STATE OF NORTH CAROLINA
DEPARTMENT OF TRANSPORTATION

February 16, 2006

Subject: **APPLICATION REVISION for Individual Section 404 and 401 permits for TIP R-2616** for the proposed widening of US 601 from the South Carolina State Line to north of Marion Lee Road (SR 2105) south of Monroe in Union County; NCDOT Division 10. Federal Project No. STP-NHS-601(4), State Project No. 8.1690303, WBS Element 34485.1.1.

**R-2616, US 601 Widening, Union County, Yadkin River Basin
(CU 03040105); Southern Piedmont (SP) Eco-Region**

Permit Application Plansheet Page **52**

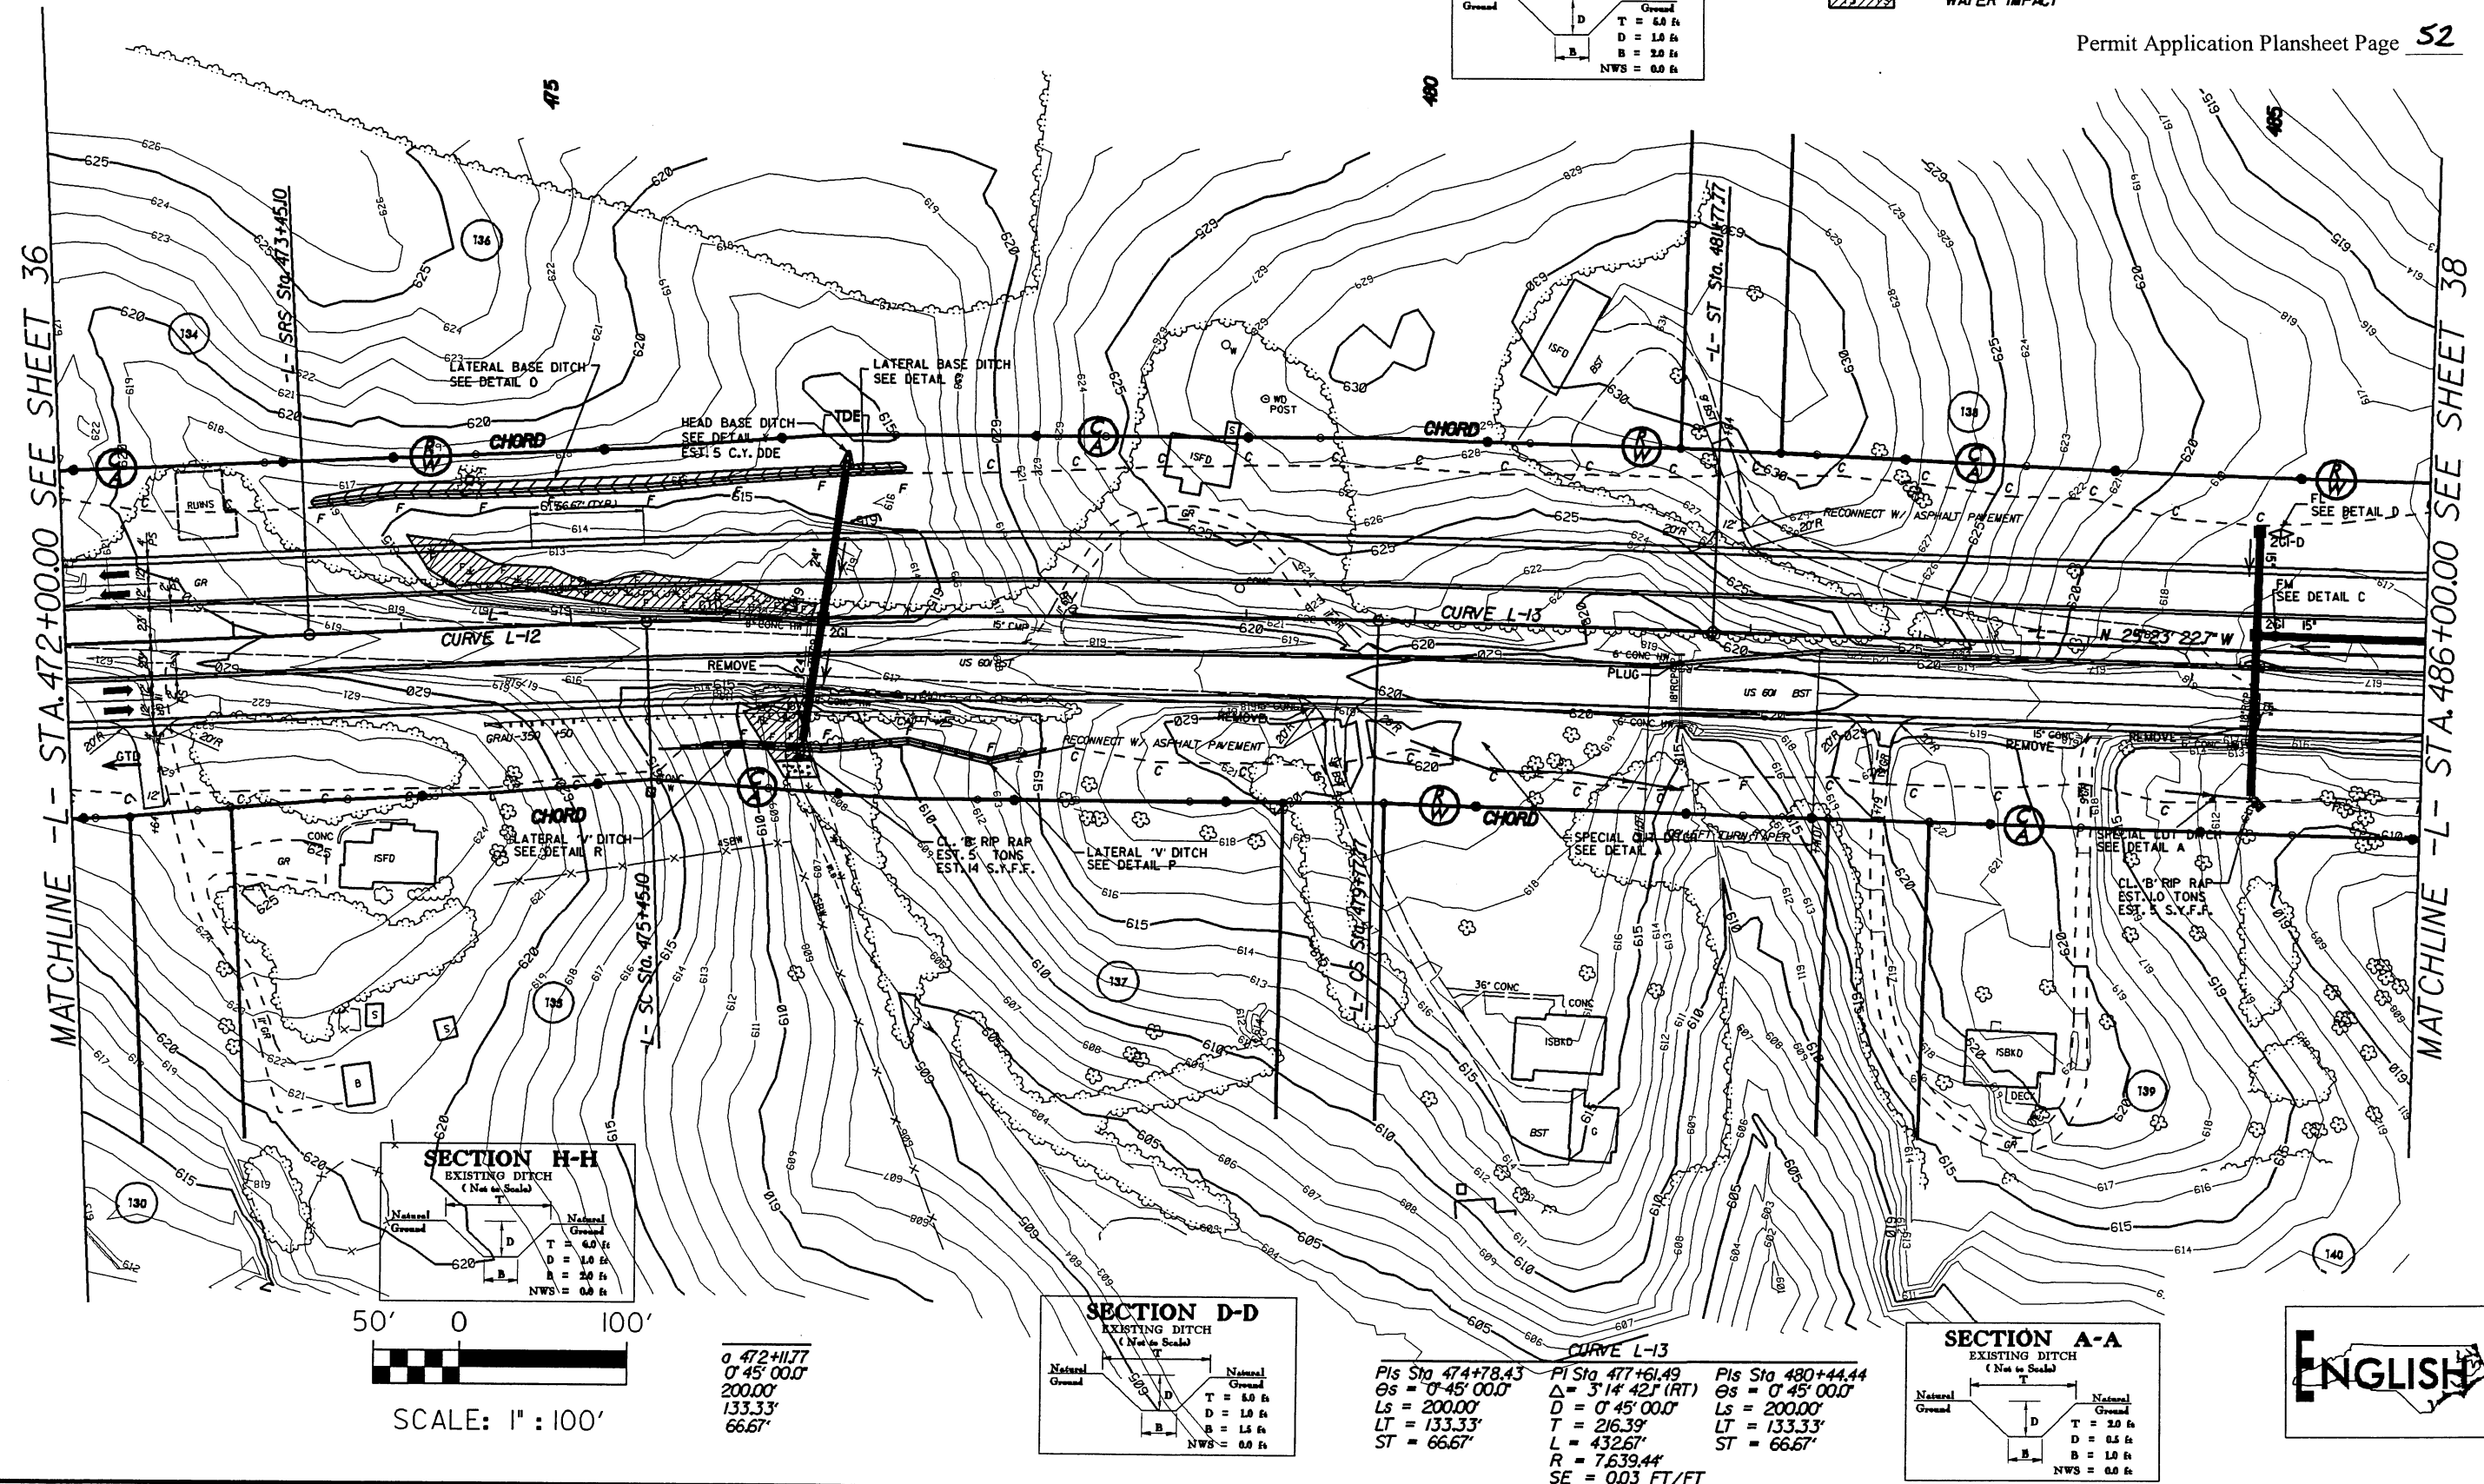
Site 23 (Permit application page 51): The permanent wetland impacts have increased by 0.09 acre (from 0.02 to 0.110 acre) due to a calculation error.

Permit Application Plansheet Page 53

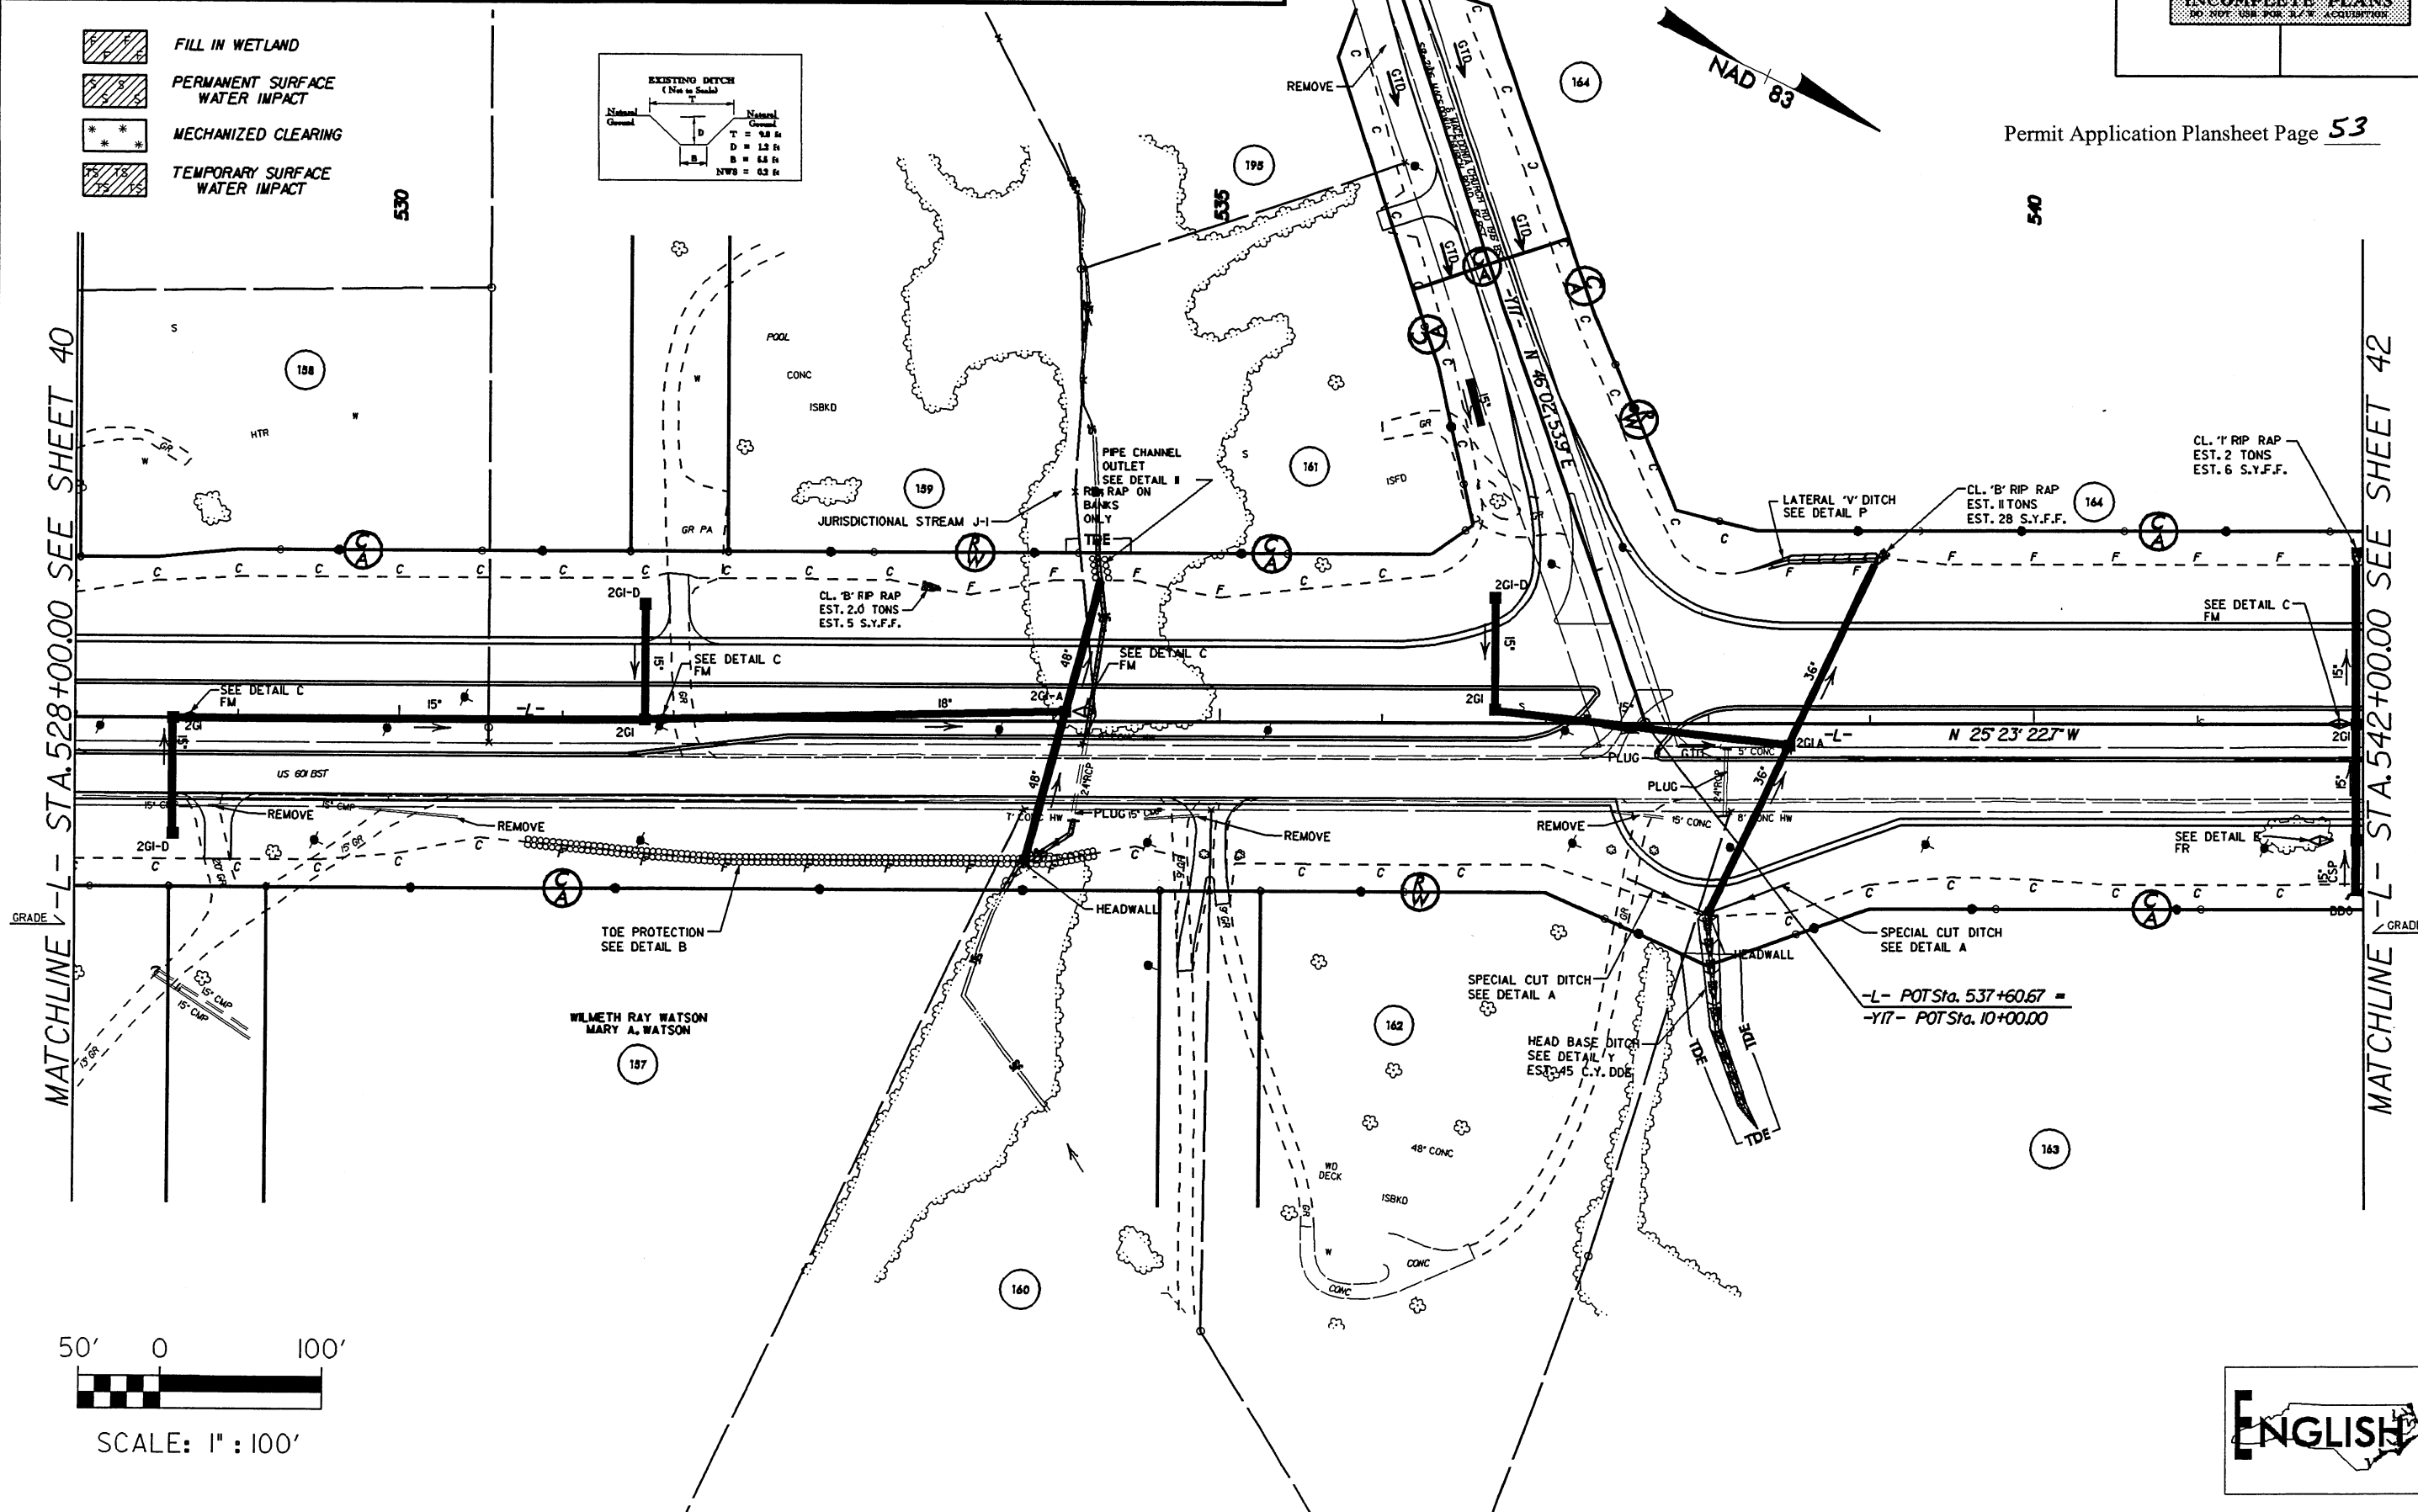
Site 24 (Permit application page 53): The temporary stream impacts have increased by 10 feet (from 20' to 30'). This change is necessary for the temporary de-watering activities for the installation of the box culverts.
